EUC Working Group Transmission Plan Review
AI Braden 09-26-23

In the 2020 Generation Plan, Transmission was raised as roadblock to retiring gas units at Decker and Sand Hill before 2035. The study was required to see if moving the retirement dates up was possible.

Austin Energy System Overview (2029 SP, Scenario 2 - Gen Retirements)

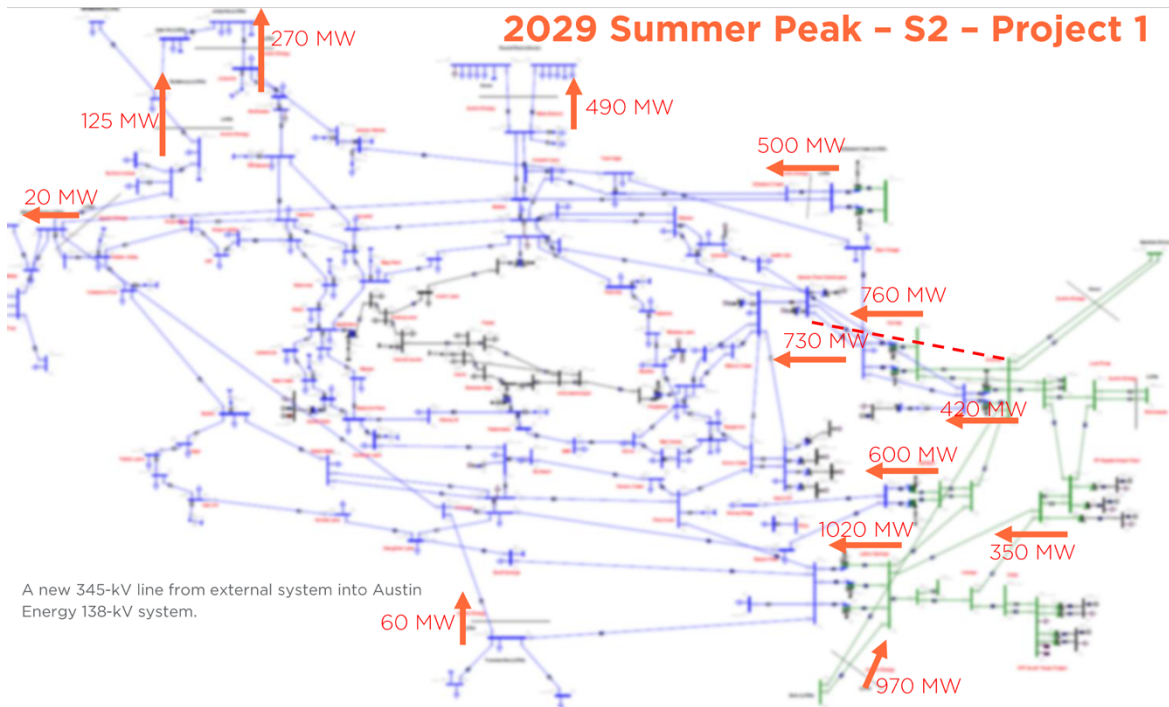
Current transmission system with gas retirements.

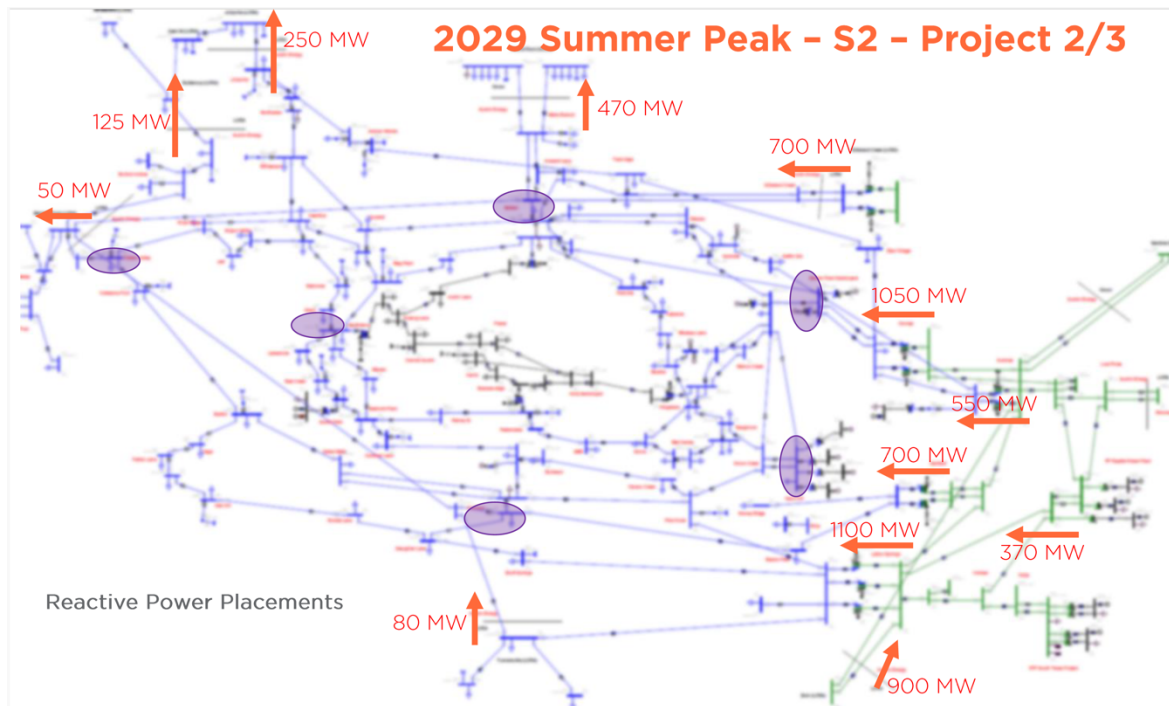
This scenario doubles down on imports from the east with a new 345 KV line.

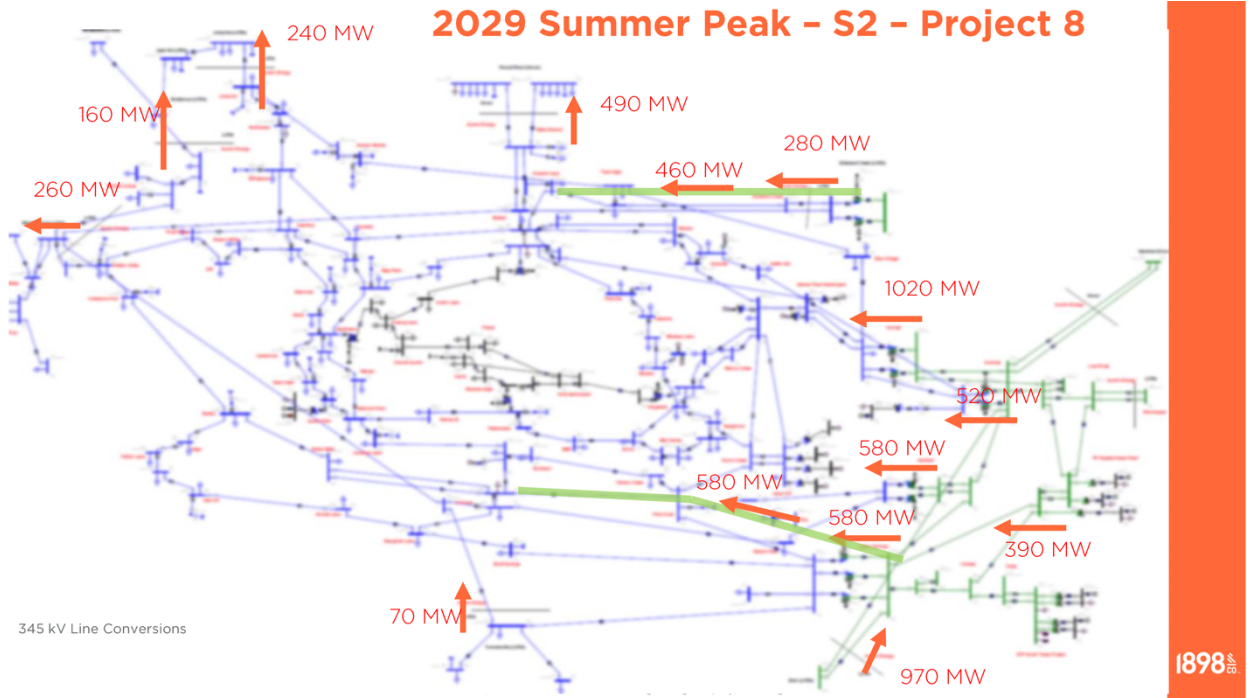
Voltage support elements needed in western areas of service territory due to exclusive power import from east.

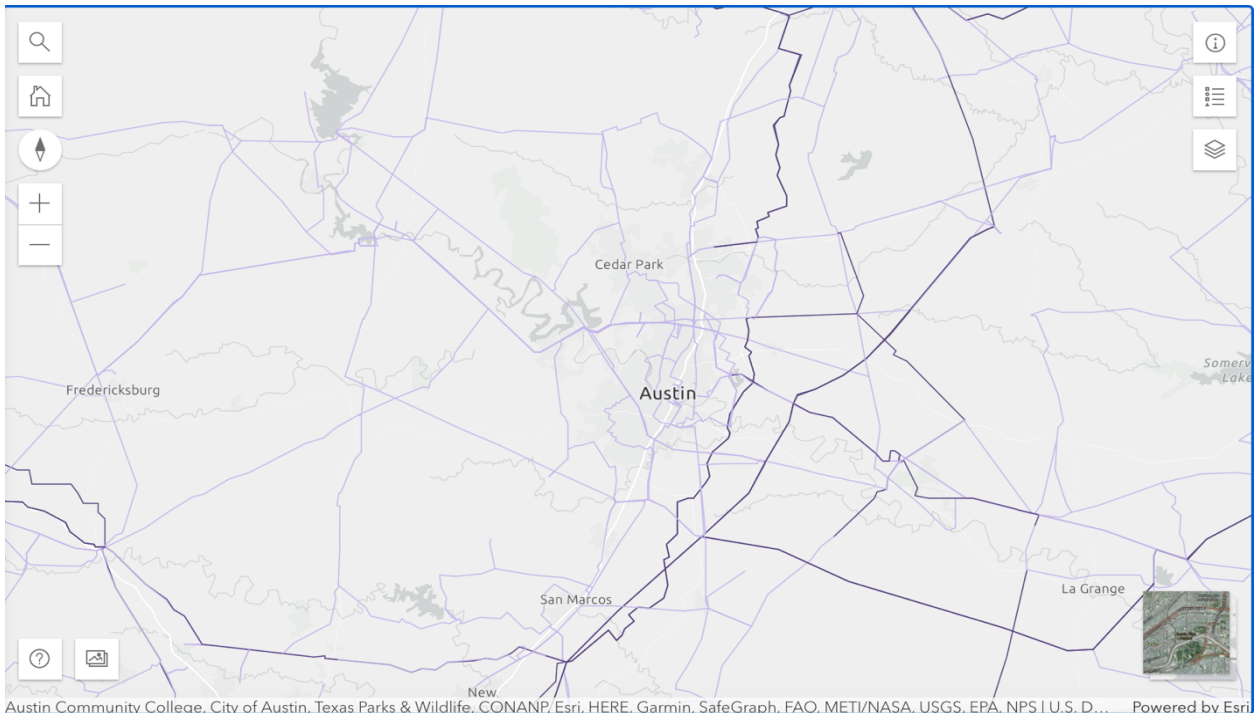
Scenario to upgrade feeds from east farther into north and south sides of service territory. Could provide half of Energy Beltway. Add a western feeder to complete loop.

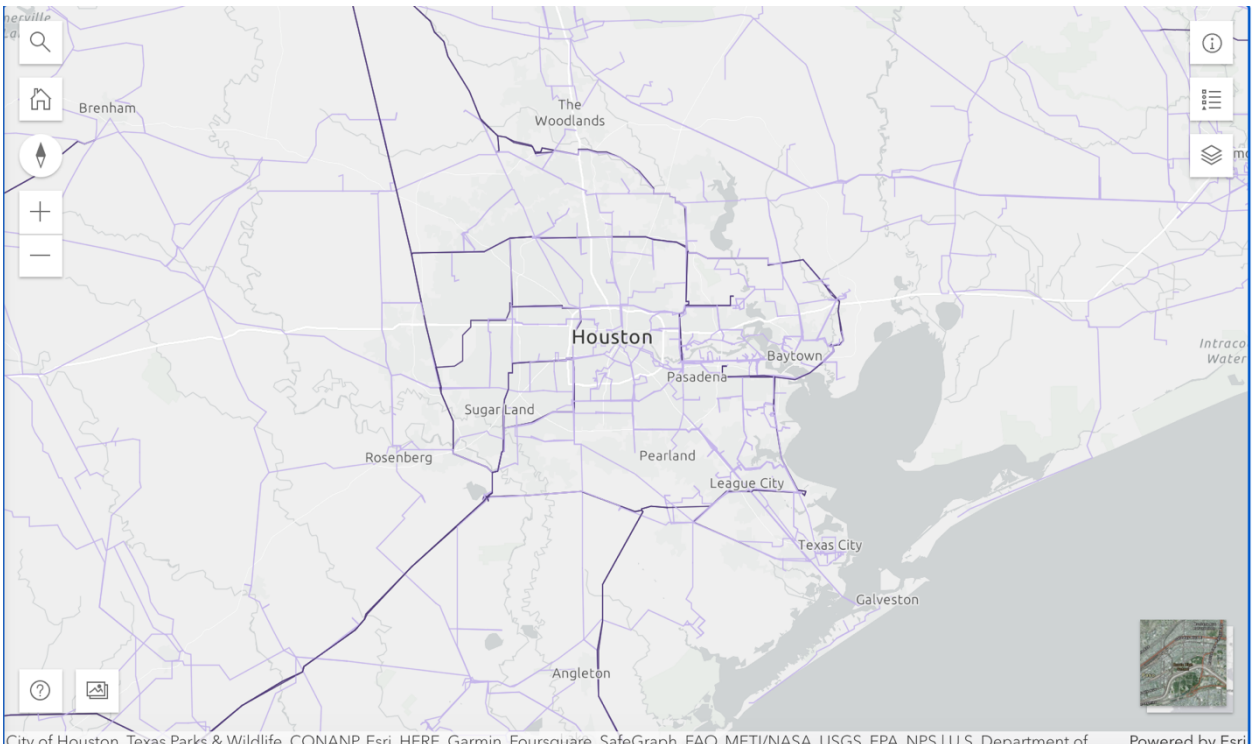
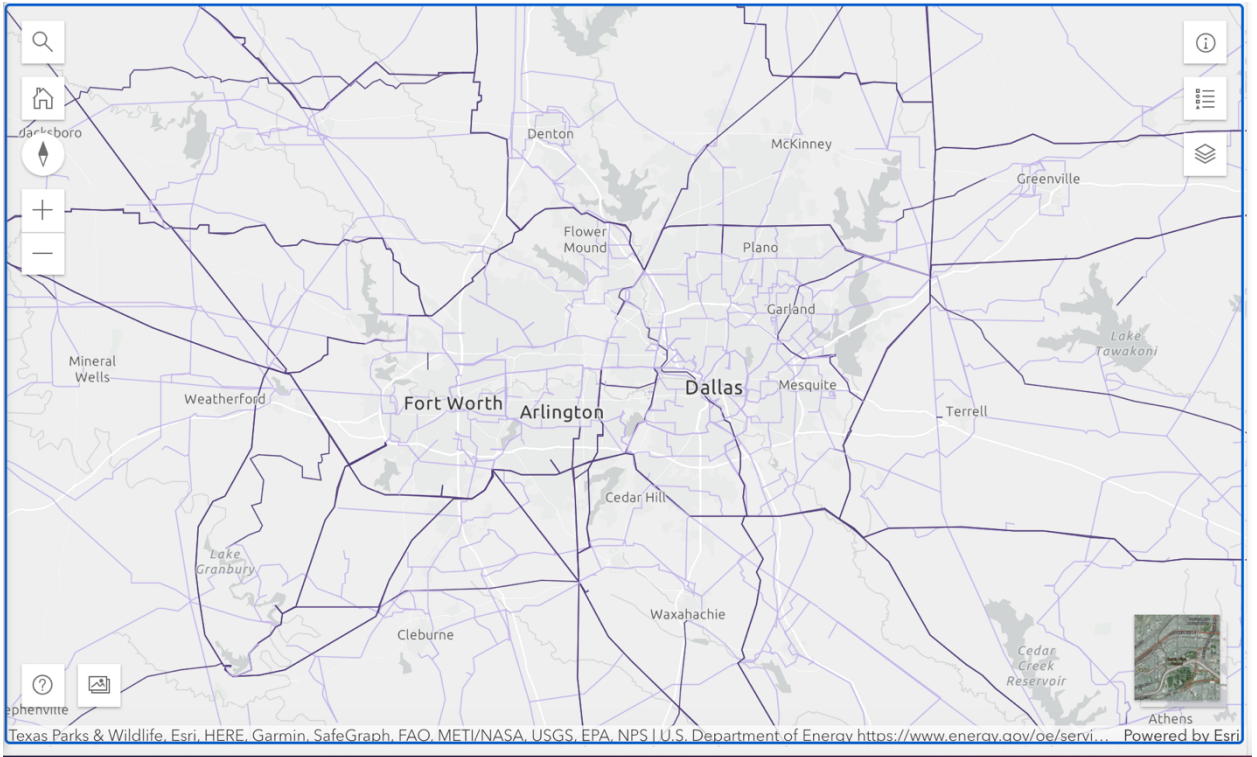
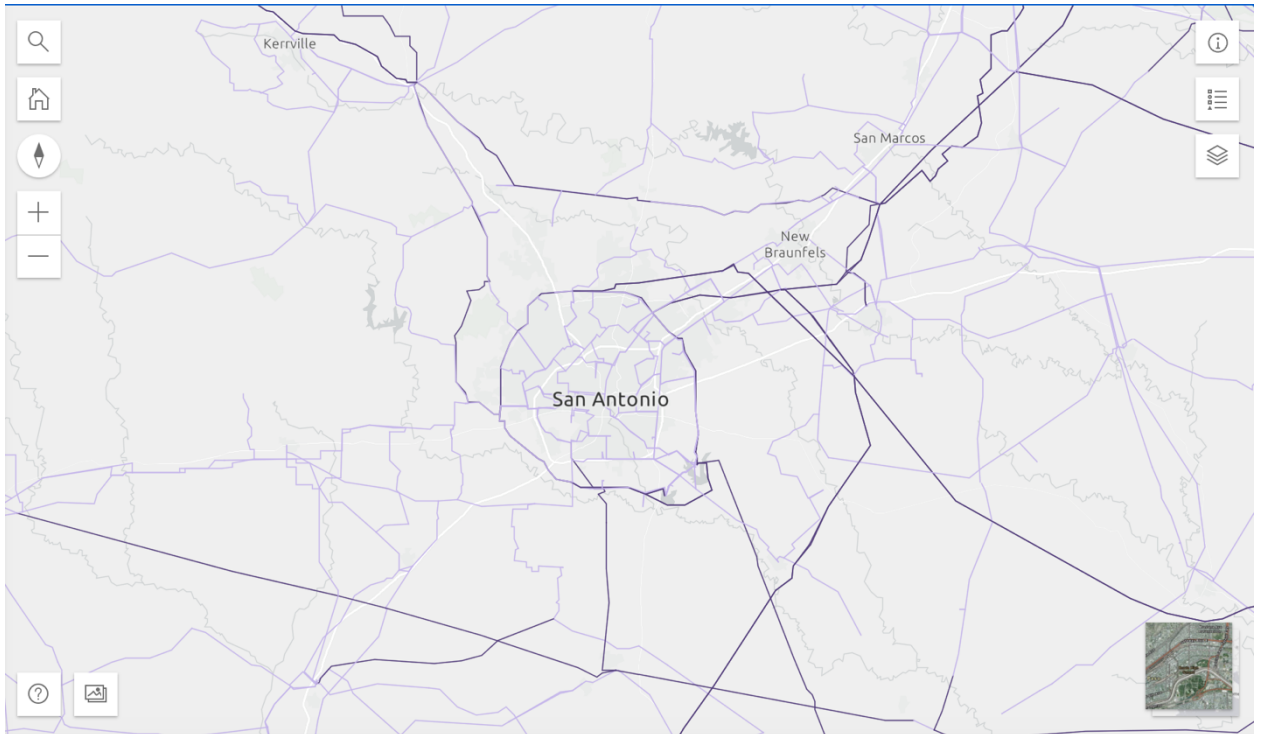
A new study should evaluate the goal of building toward an energy beltway around Austin like Texas' other large cities. It should inform our near-term high voltage connections, transformers and substation builds so as to contribute to this eventual beltway architecture.
